**SUBJECT: SERVICE BULLETIN S10RX CHARGE AIR COOLER TUBE
SUPPORT BRACKET**

MODELS AFFECTED: 2010-2011 ALL AMERICAN (D3RE)

Models Affected: 2010-2011 All American (D3RE) with Cummins ISC Engines

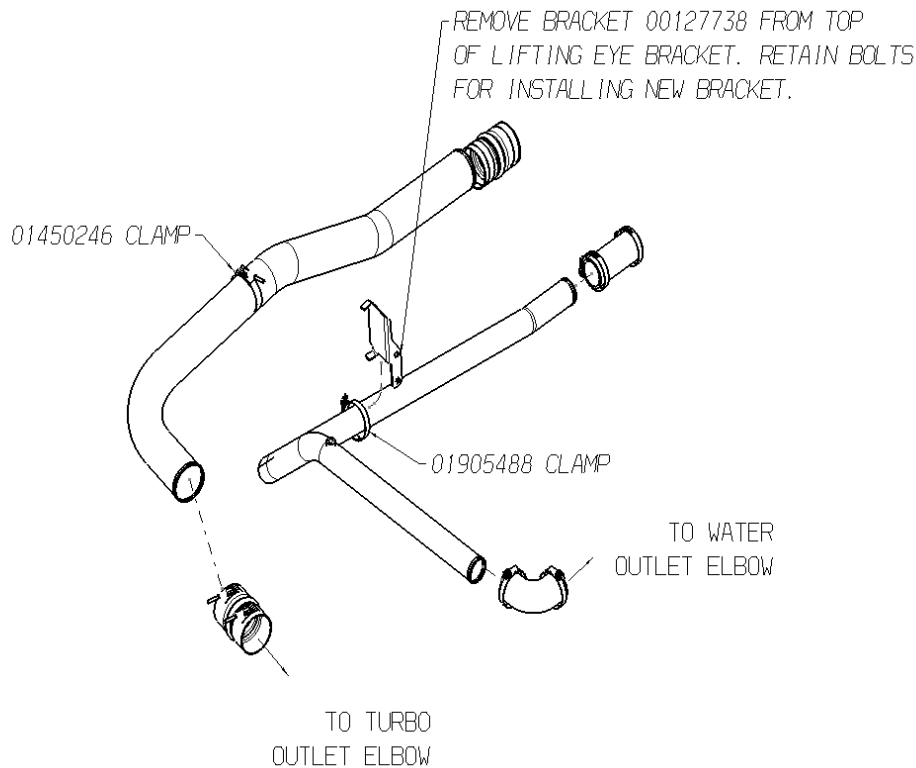
ISSUE

Charge air cooler tube support bracket may fail.

CORRECTIVE ACTION

Replace original charge air cooler tube support bracket with new bracket.

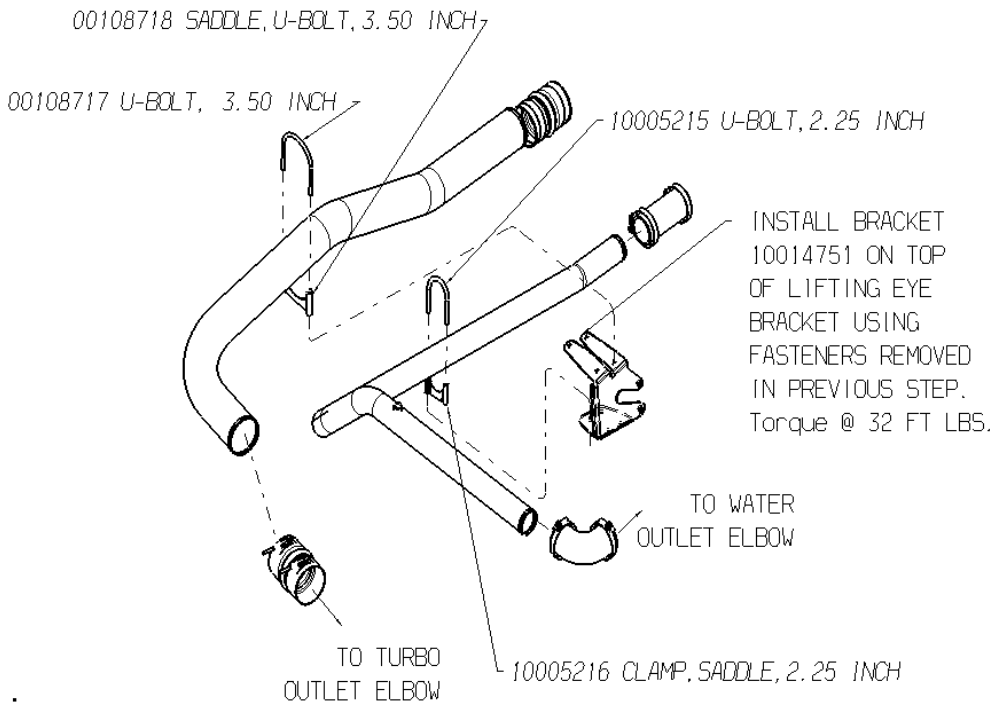
1. Park the bus on a level surface, apply parking brakes, turn off engine and remove keys. Chock wheels.
2. Remove existing charged air cooling tube support bracket, part number 00127738, and the related clamps per diagram below and discard. Retain fasteners to engine for use with new bracket.

3. Install new charged air cooling tube support bracket, part number 10014751, and the related clamping components per diagram below.
